<b>REPORT TO:</b>	Planning Committee	2 <sup>nd</sup> April 2008
AUTHOR/S:	Executive Director / Corporate Manager - Planning and Sustainable Communities

#### S/0012/08/RM - CAMBOURNE

51 Dwellings and Associated Infrastructure at Land Parcel UC09, Upper Cambourne

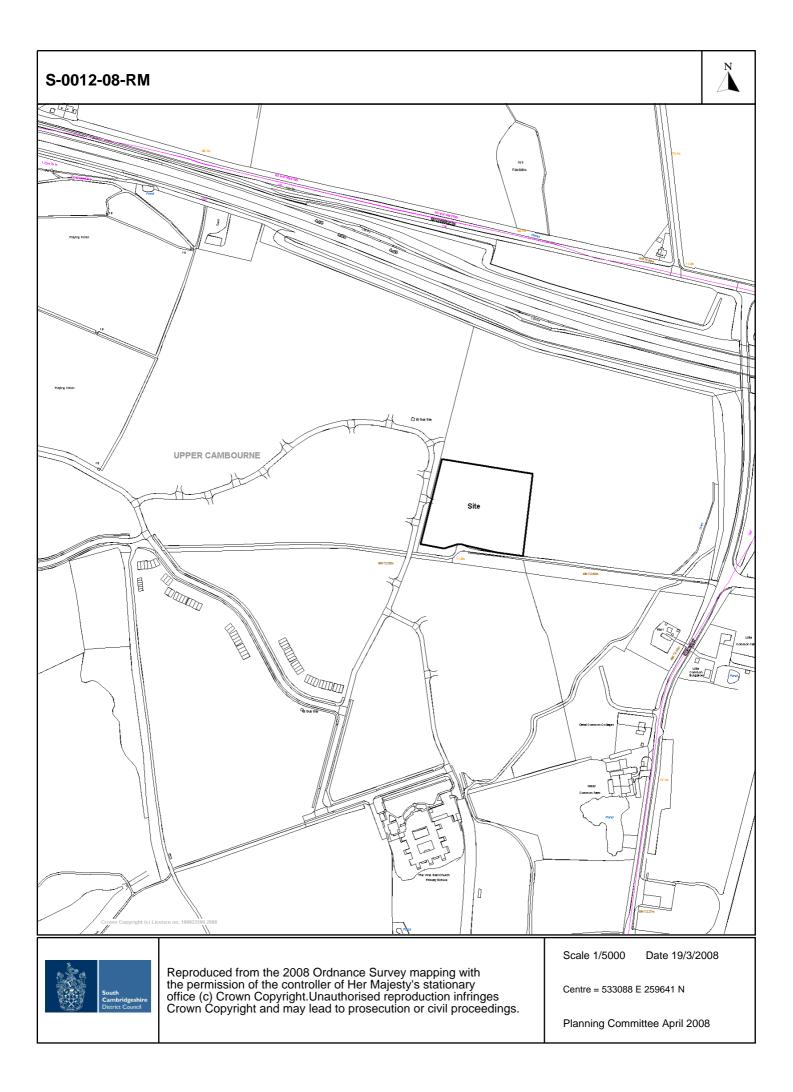
- a) "The Council considered that the layout was unimaginative and had a regimented appearance, which was below the standard of design expected in Cambourne and the Design Guides.

- b) The site is laid out to give the maximum overlooking and appears to be number led rather than design led contrary to the Development Briefing Document.

- c) The proposal appears to take no account of the connectivity, permeability and cohesion with adjoining parcels of land contrary to the Development Briefing Document.

- d) It is not clear how the adjacent development parcels merge to ensure that UC09 connects visually with adjoining parcels
- e) The access from the spine road gives the impression of a canyon and does not give the impression it is the route into a large number of dwellings.

- f) There is no clear definition of the route through the site especially adjacent to the LAP were access roads converge.
- g) The siting of the visitors parking adjacent to the LAP is a safety hazard and will cause an obstruction on route to the adjoining parcels.

- h) Long narrow drives are impractical for parking of multiple cars.
- i) The Lap although sited in accordance with the design guide and play strategy the layout and shape does not appear conducive of safe creative play.

- j) Plots 36- 41 appear to be sited to close to the southern boundary restricting access to the Carports especially if visitor parking is used and adjoining properties have their cars in their carports. There is also insufficient turning space for cars using the visitor spaces.

- k) Central parking courts should be avoided as they cause safety concerns, and require management schemes to manage which cause concerns in the future. These should designed out where possible. If they cannot be designed out alternative management schemes should be investigated.

- I) The parcel does not appear to be pedestrian friendly area.
- m) The Parish Council considered that the application was of poor quality. The Council considered that the application would have benefited from pre-planning consultation with the Parish Council so they could understand the design process for the parcel."

19. The **Police Architectural Liaison Officer** is concerned about too much permeability which might provide offenders with additional access and escape routes together with the anonymity they seek. The northern parking court area has increased vulnerability of dwellings and parked vehicles to crime, and similarly the path between plots 45 and 46. Parking in courtyards should be avoided as this provides criminal access to the rear of dwellings via fences or gates. Such courts should be protected by a gate and seen as private rather than public so that uncontrolled through passage should not be available. Similarly, adjoining parking courts create the opportunity for access between them by using cars as climbing aids.

To guard against vandalism, dwellings should have clearly identifiable defensible space such as planting strips along exposed elevations, especially where there are ground floor windows adjacent to public space such as plots 15, 36 and 49. The areas to the rear of plot 11, and rear of plots 9, 10 and 12 should be gated off to

provide additional security and prevent the area becoming attractive for people to gather unseen. Roads, communal driveways, footpaths and parking courts should be lit.

- 24. The Parish Council's concerns are noted. However, the required connectivity with adjacent parcels is provided, through the road link to the east, and the pedestrian links to the north, west and to the greenway to the south. The adjacent parcels have yet to be designed so visual connection with them will be dictated by this parcel. Nevertheless, the layout allows for runs of houses to be continued into the next sites, and there are no awkward relationships with boundaries that would make the design of the adjacent parcels difficult. The requirements of the Briefing Document will assure visual connectivity. The entrance to the site from the spine road is similar to many others in Cambourne and is in some ways a consequence of the need for houses to face the spine road rather than the estate road, that being the priority in terms of the street scene. In positive terms it means that the main route along the spine road is more obvious, leading to less confusion as to the routes through the settlement. The definition of the route through the site will be achieved through a condition requiring the agreement of surfacing materials, so that side roads ending in a cul-de-sac are surfaced differently, leaving the main route clearly defined. The visitor parking adjacent to the LAP has been removed in the amended plans. Parking standards are met appropriately and the LAP has a clear 100sg.m. square shape within its overall larger shape so that it is useable, and will be appropriately fenced for safety and access. The concerns about parking for plots 36-41 appearing to have restricted access to their carports has been demonstrated by a "swept path" drawn over the layout, although the length of access is short enough for vehicles to reverse out into the cul-de-sac access road. It is not agreed that the parcel does not appear to be pedestrian friendly area, as several of the footpaths through the site, especially north-south, are segregated from the highway by verges. There are clear pedestrian routes on footpaths and shared surfaces in cul-de-sac locations.

25. The Police Architectural Liaison Officer's comments have been partly addressed through the amended plans, and landscaping and lighting conditions will be added.
